PLANNING CLEARANCE
(Single Family Residential and Accessory Structures)
Grand Junction Community Development Department

BLDG ADDRESS 2381 Pleasant Ridge Ct. TAX SCHEDULE NO. 2945-174-33-023

► APPROVAL FOR BUILDING PERMIT ◀
Ridges Architectural Control Committee (ACCO)

Job No. 94-19
 Builder or Homeowner MC Const
 Ridges Filing No. 6
 Block 29 Lot 23A
 Pages Submitted 4
 Date Submitted 5-31-94

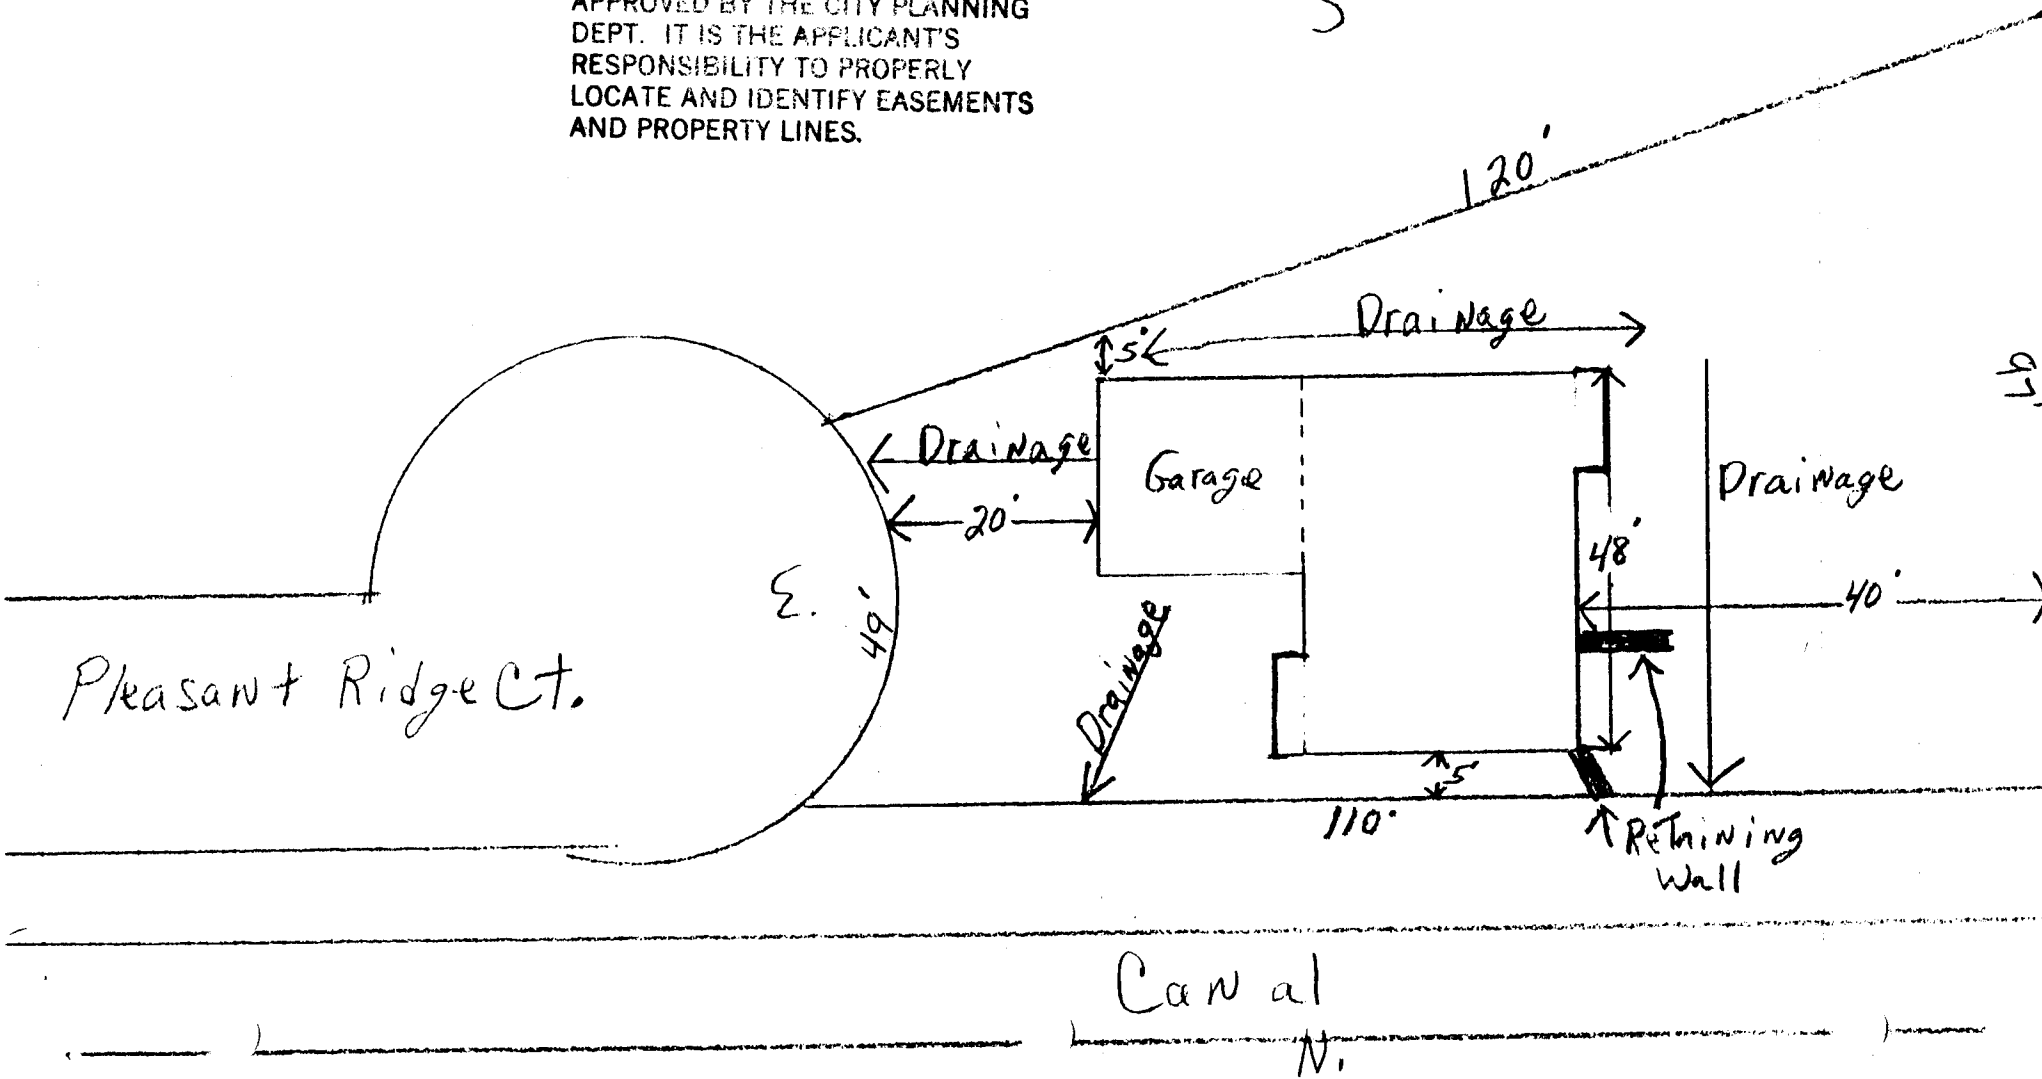
ACCEPTED MP 6-14-94
ANY CHANGE OF SETBACKS MUST BE
APPROVED BY THE CITY PLANNING
DEPT. IT IS THE APPLICANT'S
RESPONSIBILITY TO PROPERLY
LOCATE AND IDENTIFY EASEMENTS
AND PROPERTY LINES.
